HISTORIC AND DESIGN REVIEW COMMISSION

July 19, 2023

HDRC CASE NO: 2023-229
ADDRESS: 123 N ST MARYS ST (St. Mary's Street Bridge, River Level)
LEGAL DESCRIPTION: NCB 106 (HILTON CANOPY HOTEL), LOT 36
ZONING: D, H, RIO-3, Right of Way
CITY COUNCIL DIST.: 1
APPLICANT: Grace Boudewyns/Lake Flato Architects
OWNER: 155 E COMMERCE HOTEL LLC
TYPE OF WORK: Installation of site elements and construction of an outdoor bar beneath the N St Mary's river bridge
APPLICATION RECEIVED: June 06, 2023
60-DAY REVIEW: August 05, 2023
CASE MANAGER: Edward Hall
REQUEST:

Proposed Lumo Outdoor Bar Plan

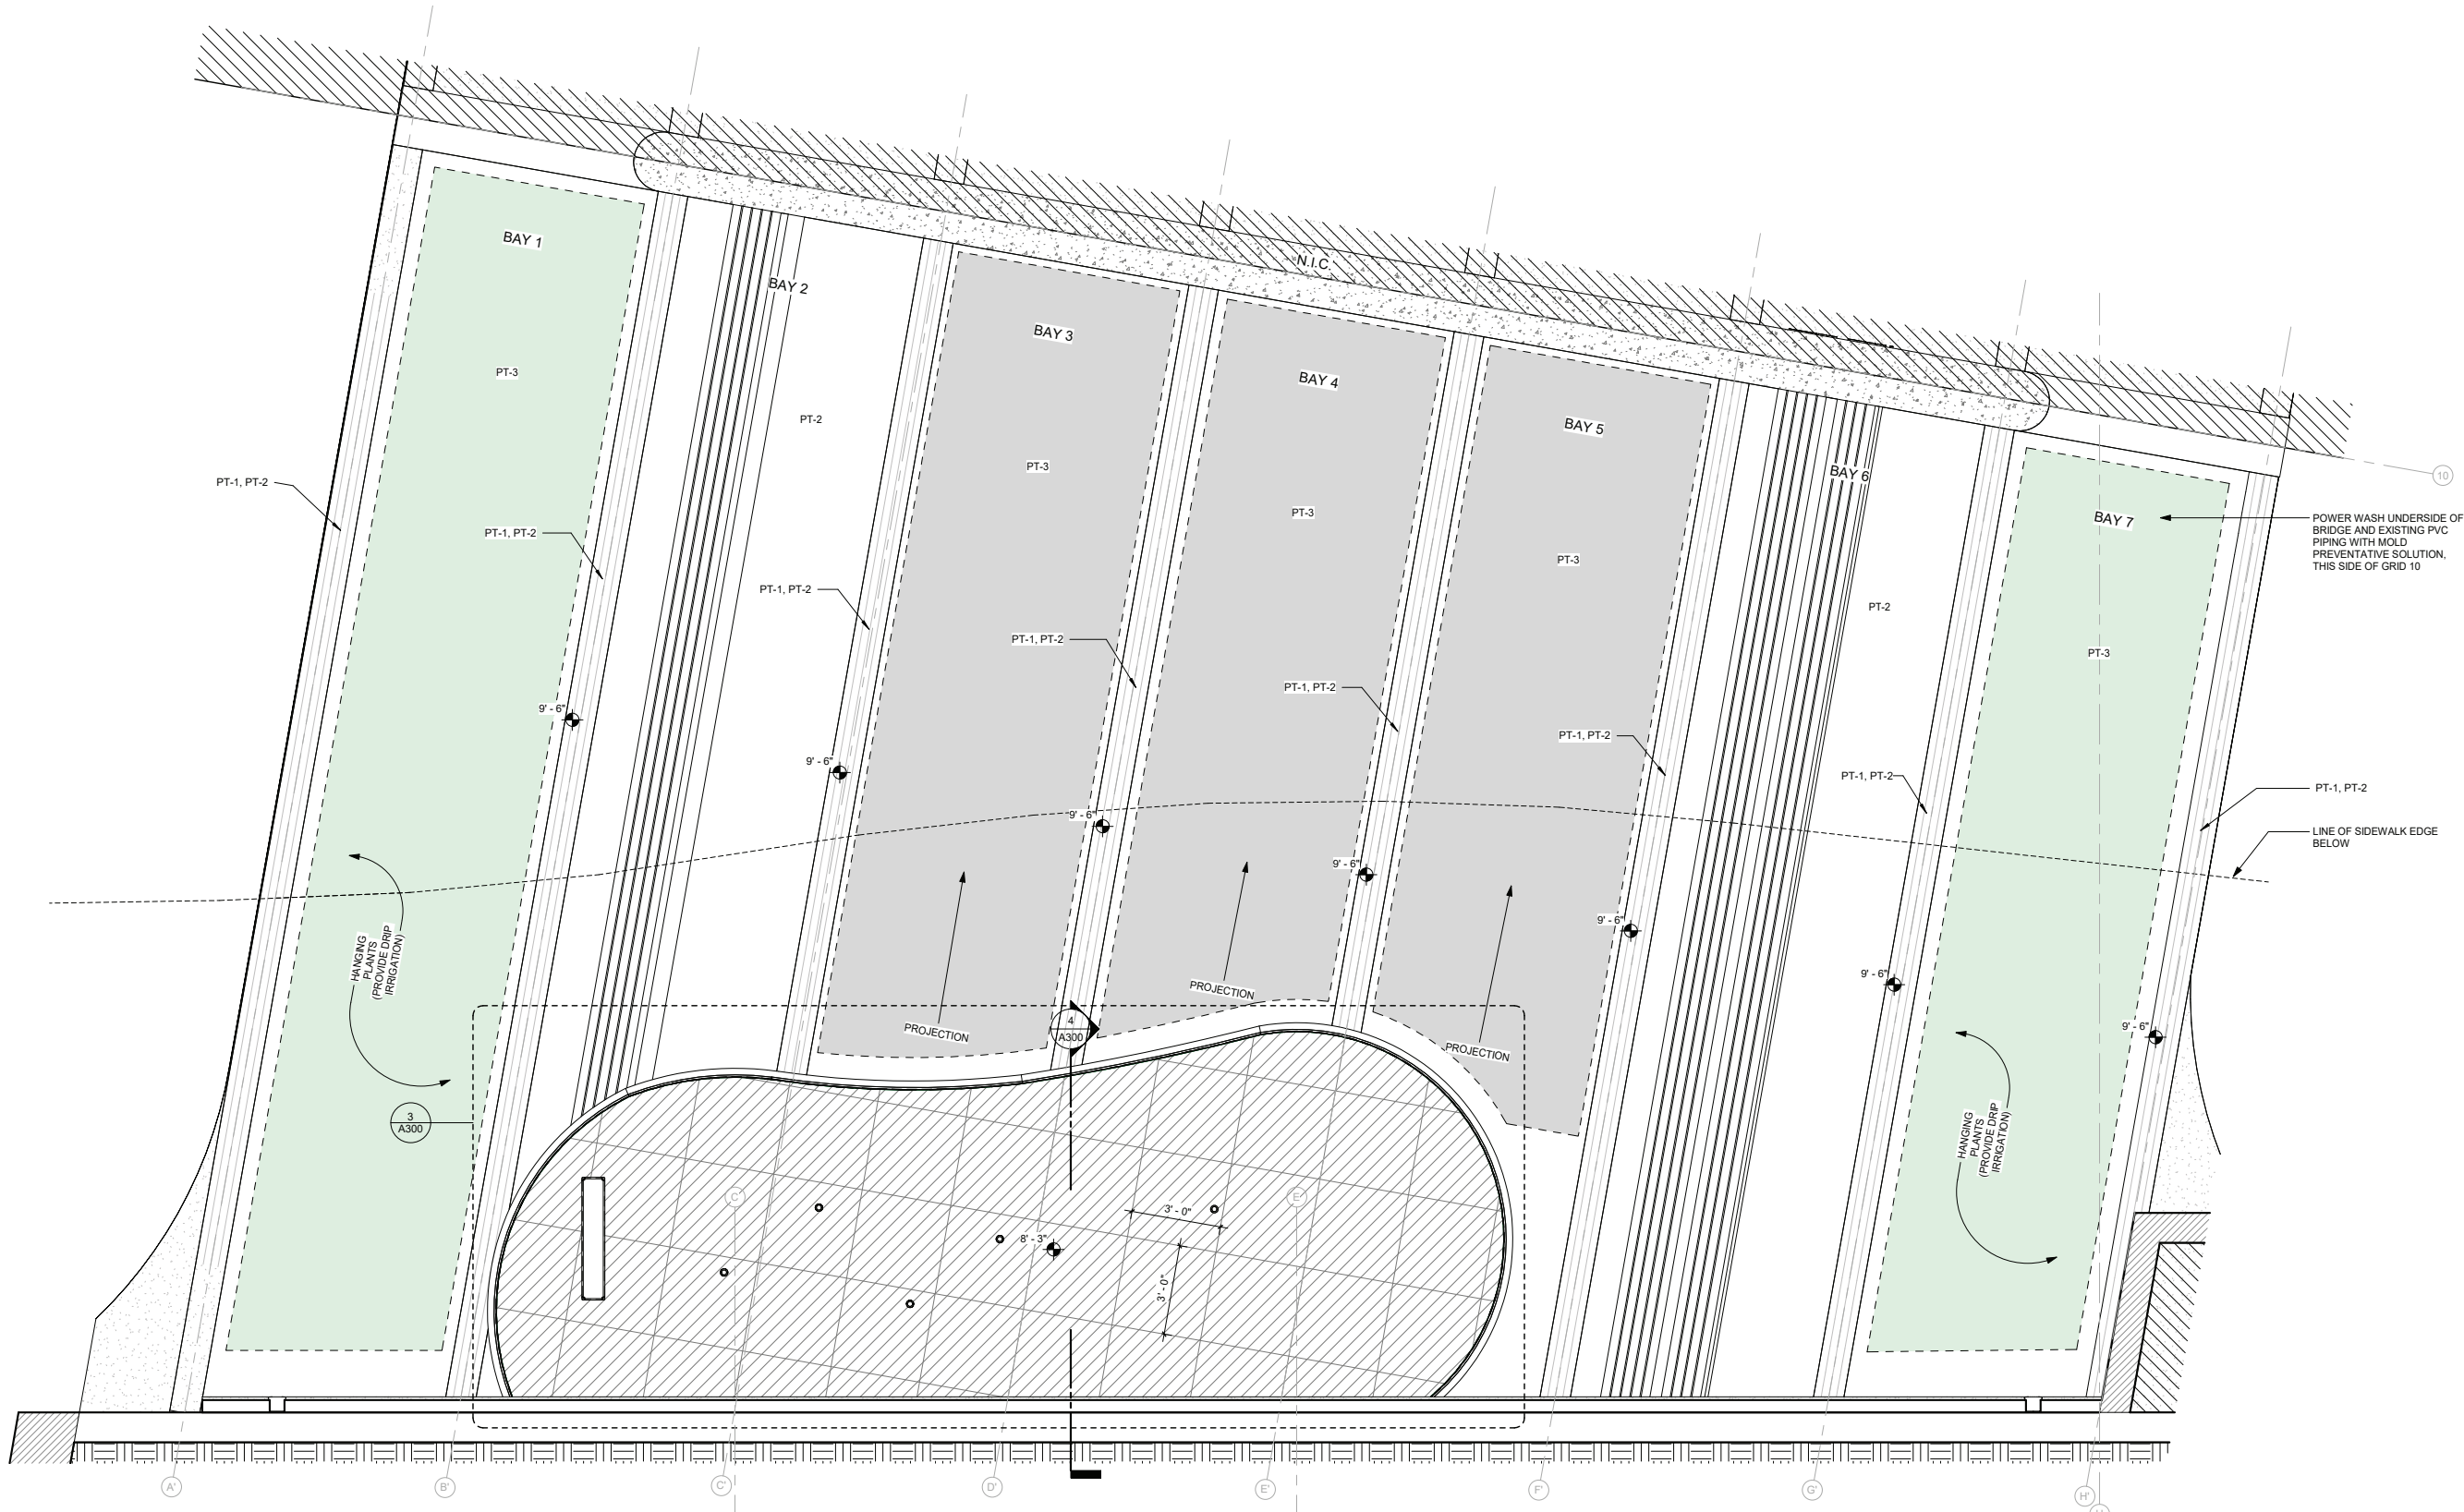
- b. BAR SPACE – The applicant has proposed to install an outdoor bar within the right of way beneath the St Mary's Street Bridge. The bar will feature the construction of a bar with both standing room and seating, two seating islands, seating walls, and planters to control queuing line formation. The applicant has noted that the historic elements on site, including original Hugman sidewalk panels, the original stone retaining wall and two catchment basins will remain. The proposed bar will require the removal of six (6) existing, concrete stools. These stools are not found on Hugman documents. Generally, staff finds the proposed bar and modifications to the site to be appropriate.

- e. MATERIALS – The applicant has proposed materials that include translucent glass in mortar for the bar structure and seating islands, a side folding enclosure, an overhead fan, and a sandblasted concrete floor finish. Generally, staff finds the proposed materials to be appropriate and consistent with the UDC Section 35-674(i)(2).
